MONITORING YEAR 1 ANNUAL REPORT FINAL

OAK HILL DAIRY MITIGATION SITE

RE: Oak Hill Dairy Draft MY1 Report Review
Catawba River Basin – CU# 03050102 – Gaston County
DMS Project ID No. 100120
Contract # 7867

Wildlands Engineering, Inc. (Wildlands) has reviewed the NC Division of Mitigation Services (DMS) comments from the Draft Monitoring Year 1 (MY1) Report for the Oak Hill Dairy Mitigation Site. The DMS's comments and Wildlands' responses are noted below.

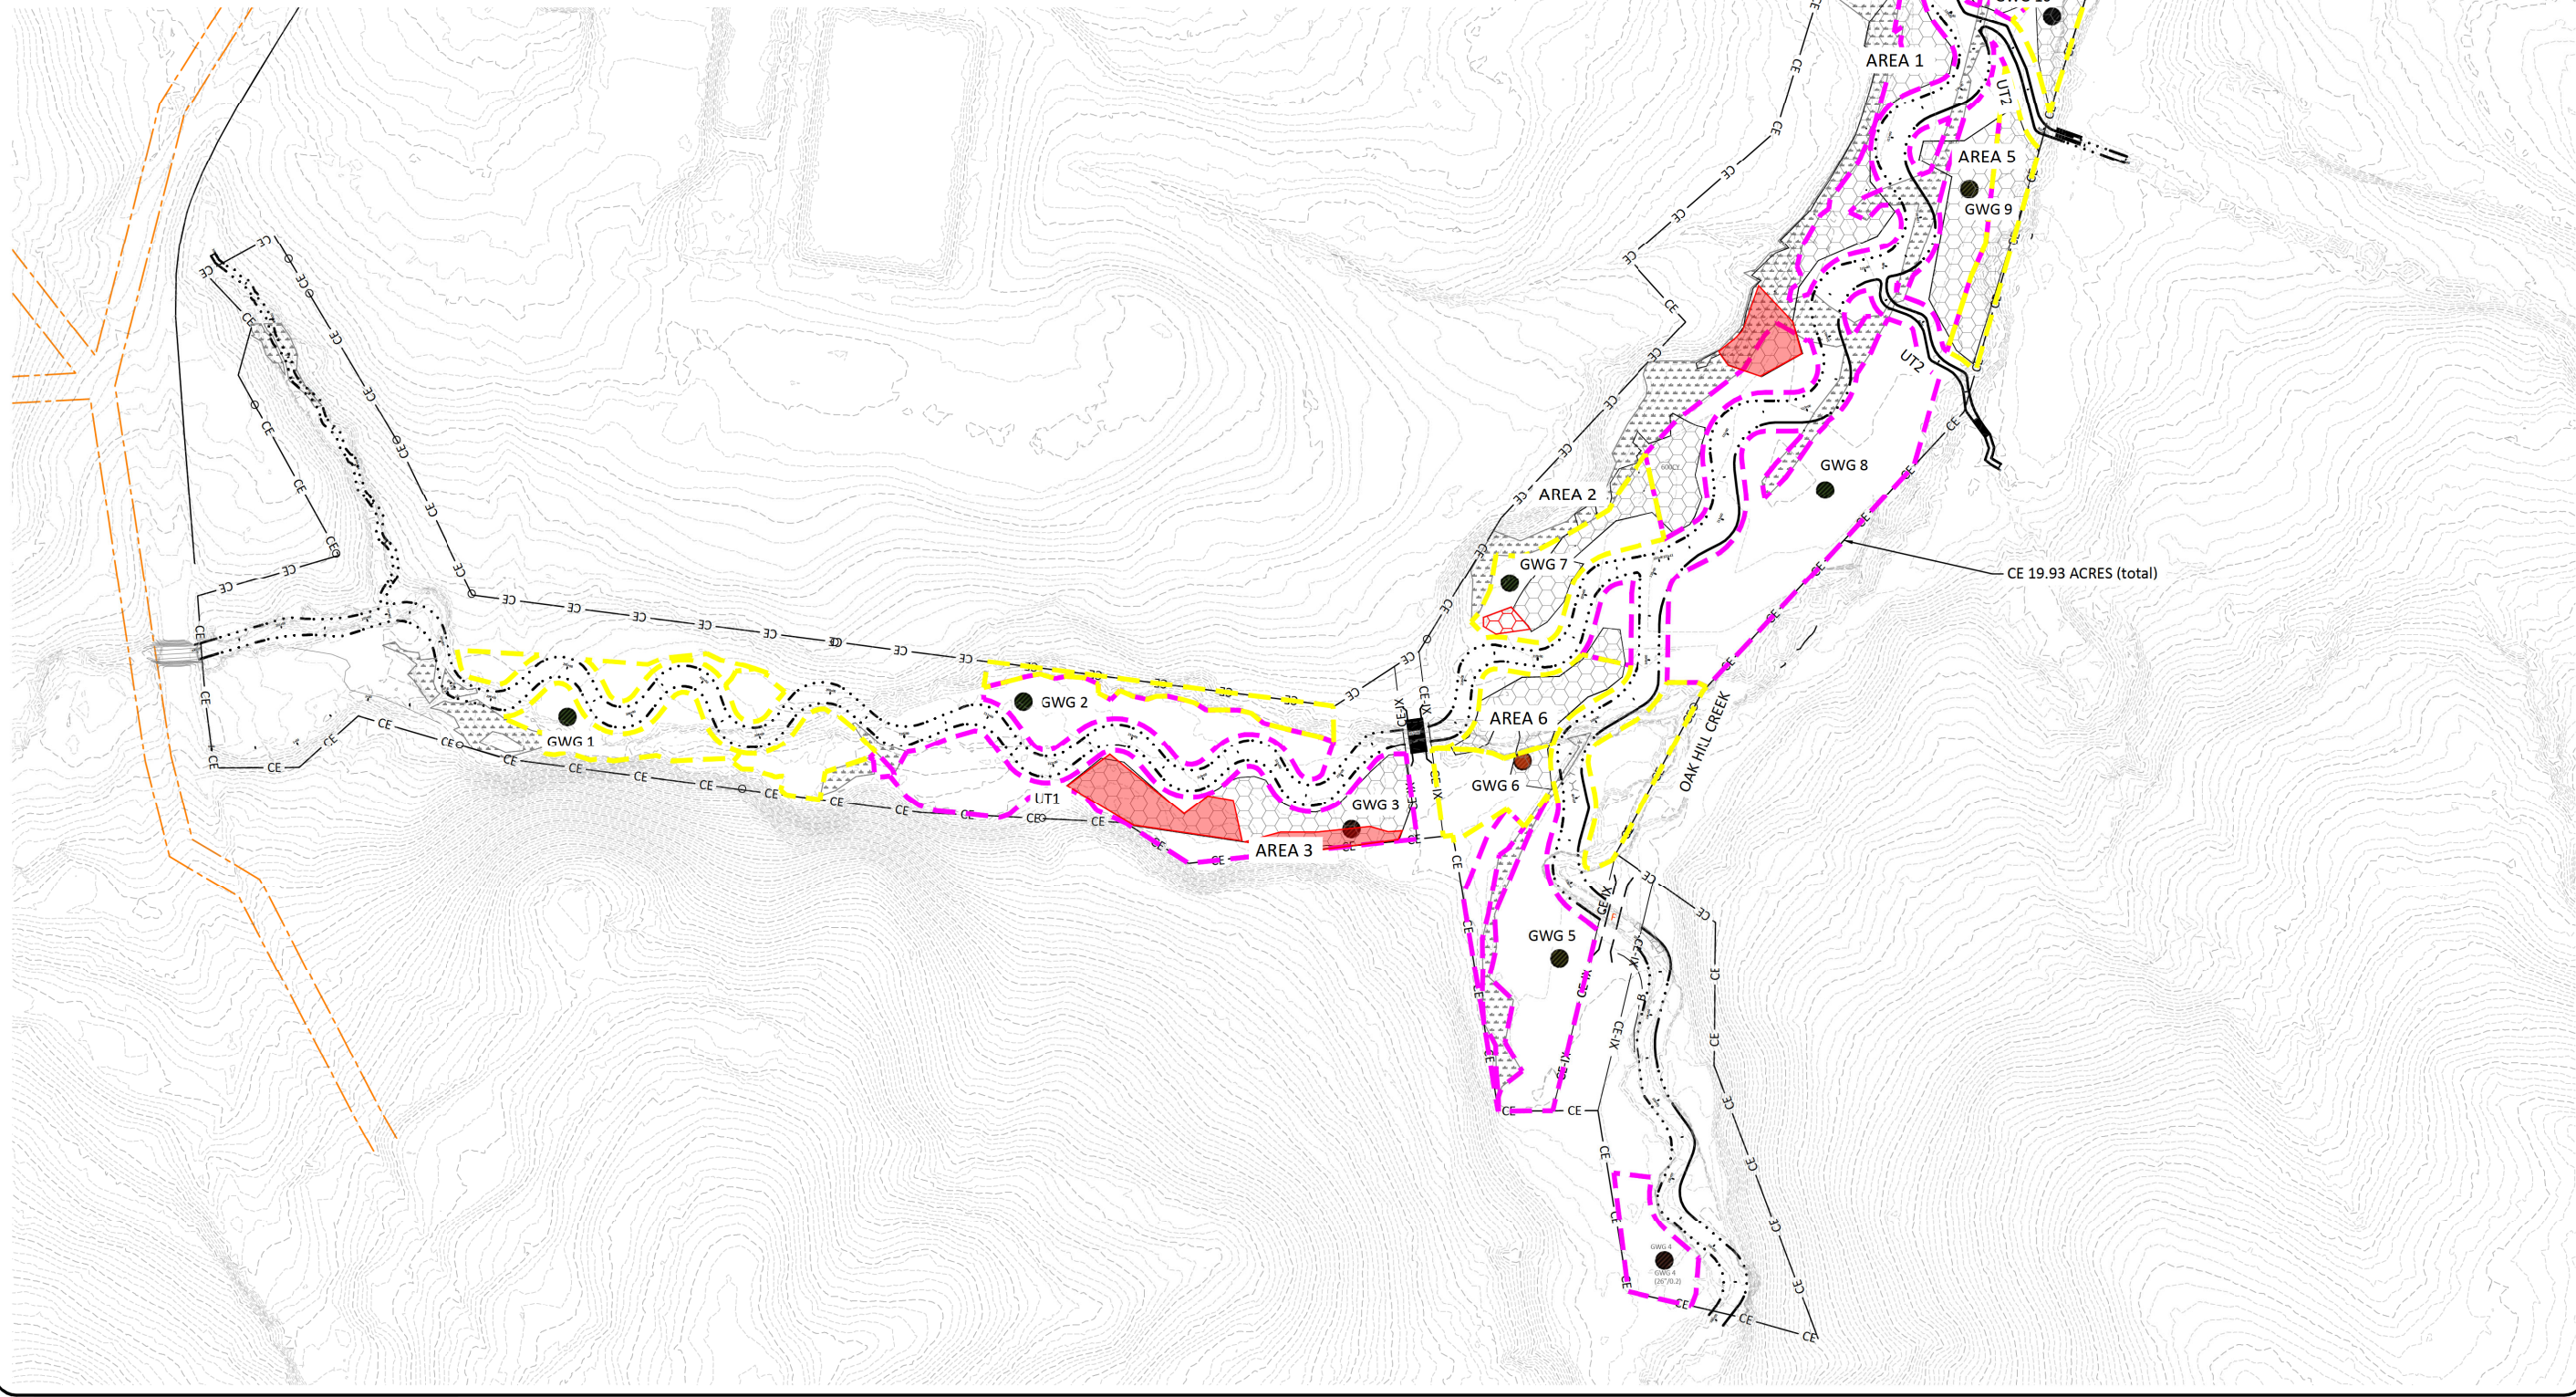
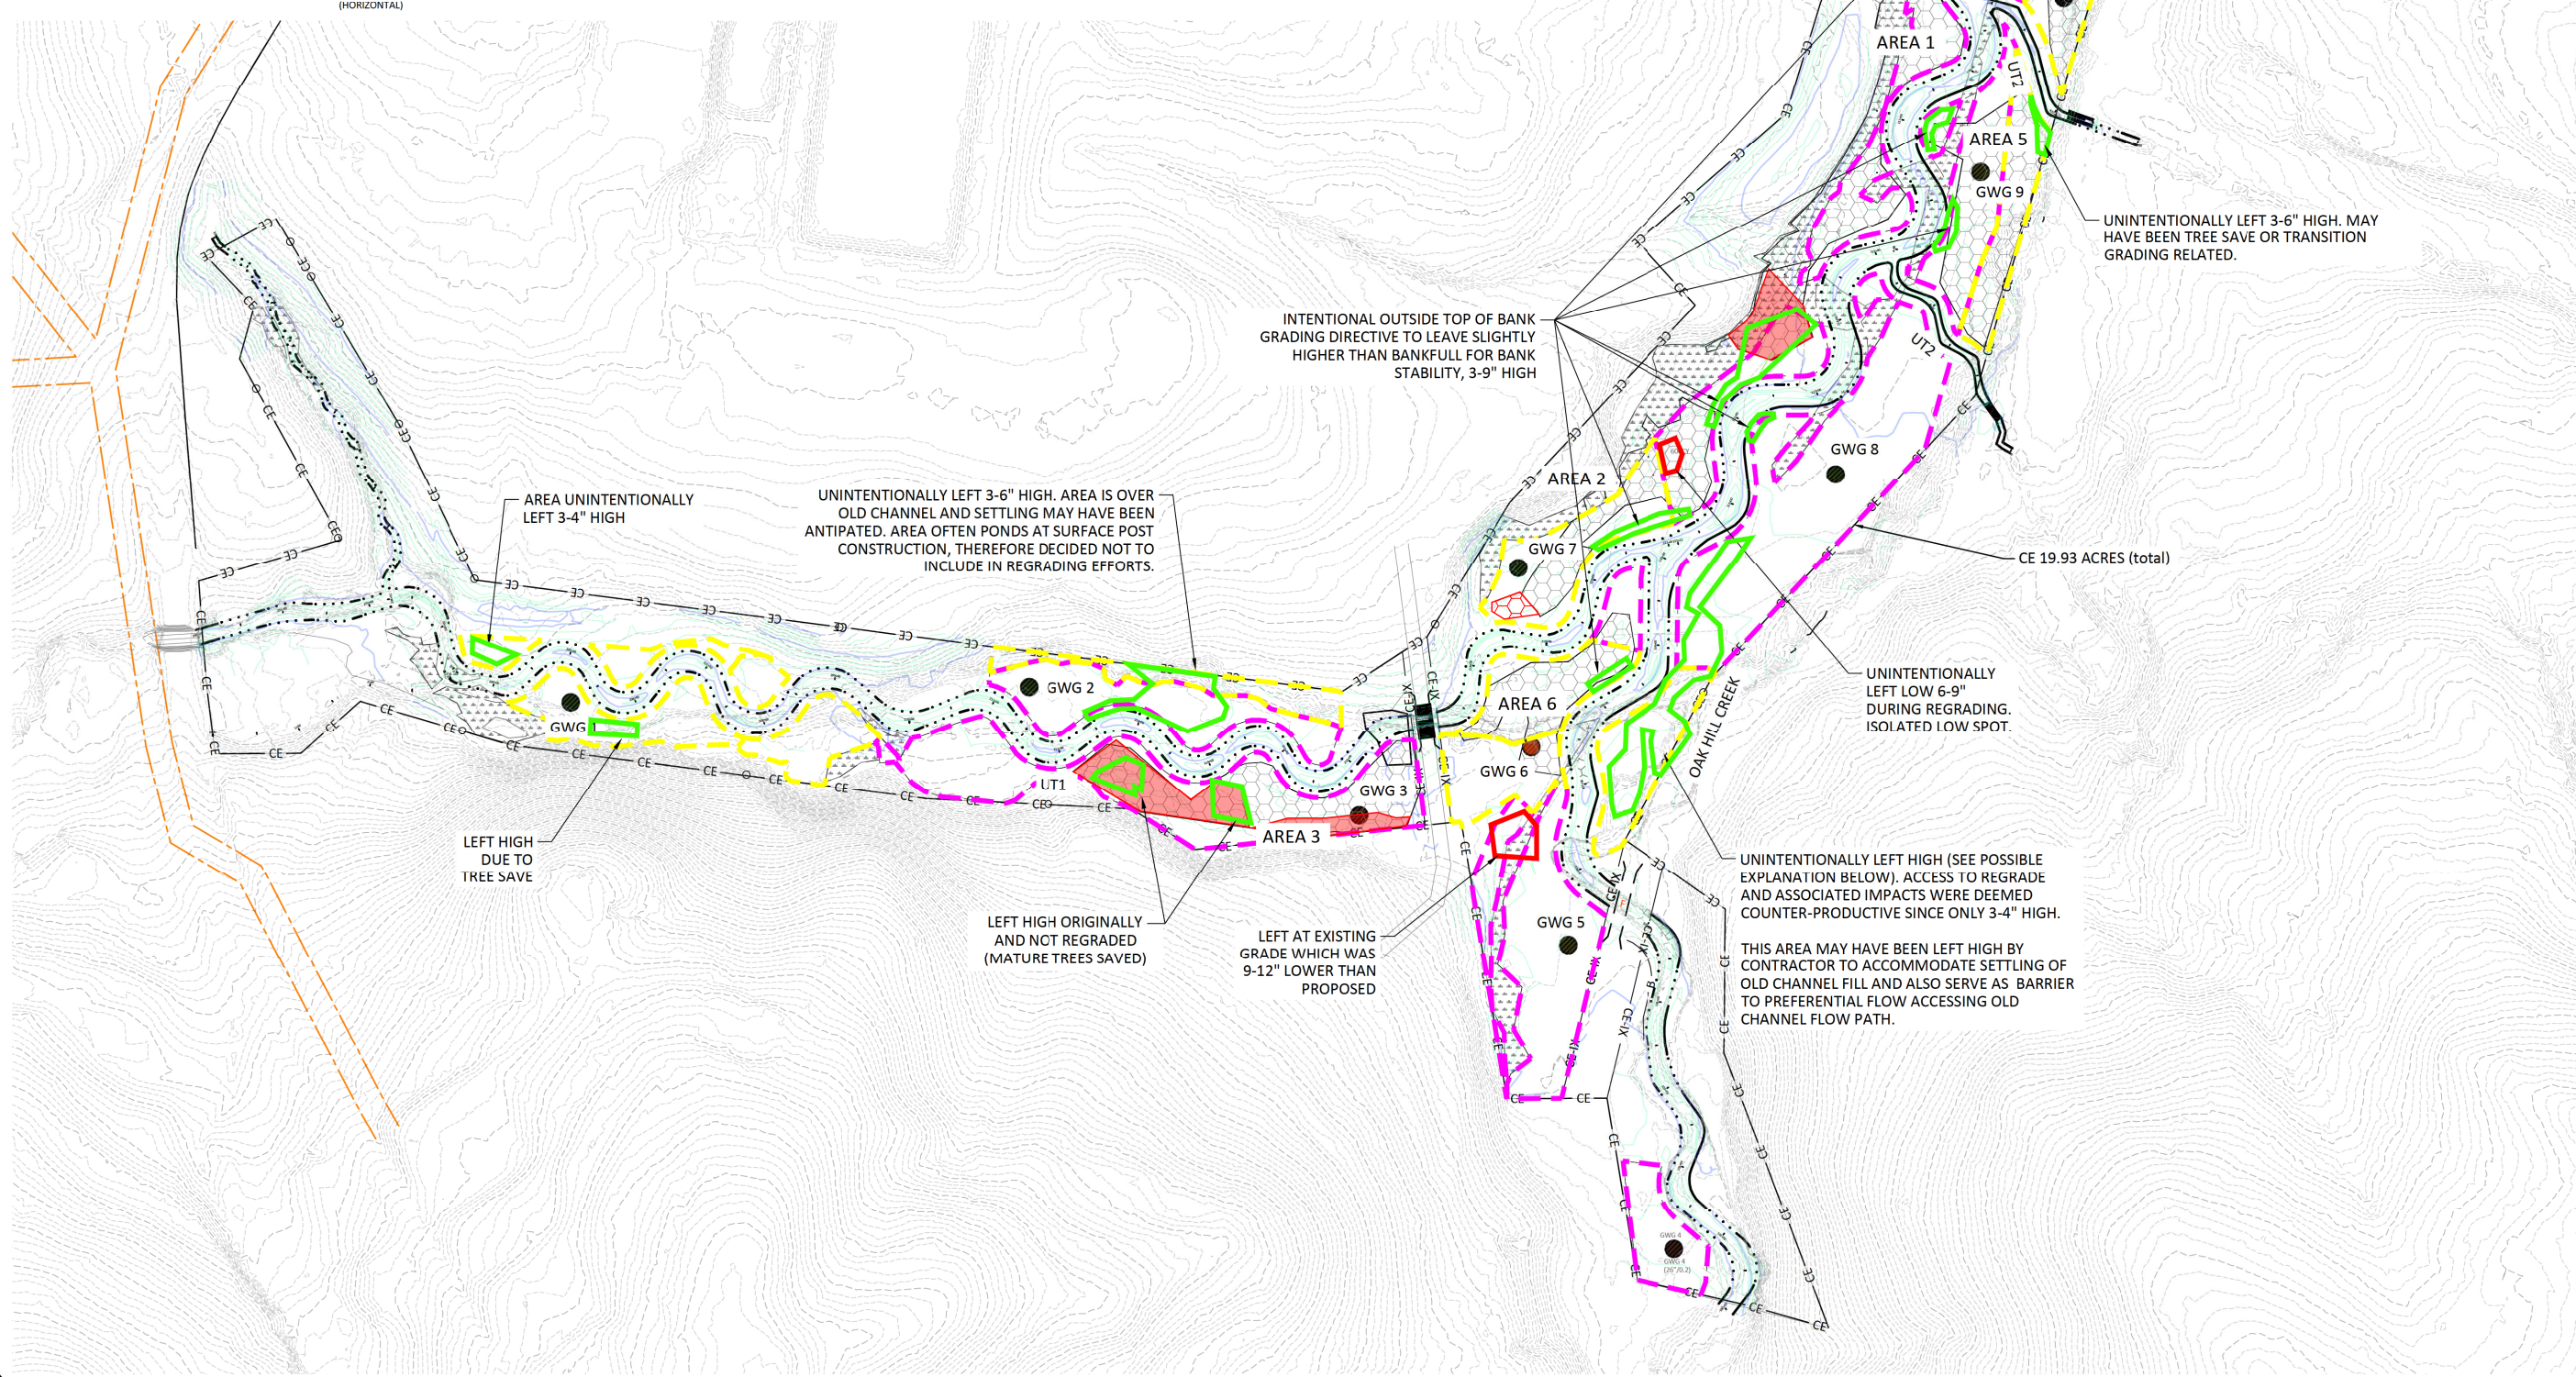
3. *Appendix F shows a map of potential wetland areas to be regraded to design grade from the August 8, 2022 IRT memo, but it is unclear if all these areas were regraded. Provide a figure that shows which areas were regraded including the BMPs and whether any remaining areas do not match the approved design. If areas currently are not meeting design grade or were graded deeper than the approved, please provide a figure that shows grading depths using pre-and-post construction survey data.*

Wildlands Response: The areas that were proposed for regrading were approximately the same as those ultimately regraded during the fall 2022 regrading efforts. A figure of regraded areas is being provided that shows the minor field changes. BMPs were not regraded. The figure title is: "Regraded Areas – Prop. Vs. Actual". (Continued)

An additional figure of areas that were left higher or lower than the proposed design is being provided as well. Information is provided on this figure discussing each area that was left high or low. Only three areas were graded (or left) deeper than proposed and the figure indicates the depth of these areas. The figure title is: "Areas Higher and Lower than Design Grade".

THESE WERE ACREAGE AND DEPTH ESTIMATES FROM ORIGINAL EFFORT AND ARE CONSISTENT WITH WORK ACTUALLY PERFORMED.

THESE WERE ACREAGE AND DEPTH ESTIMATES FROM ORIGINAL EFFORT AND ARE CONSISTENT WITH WORK ACTUALLY PERFORMED.
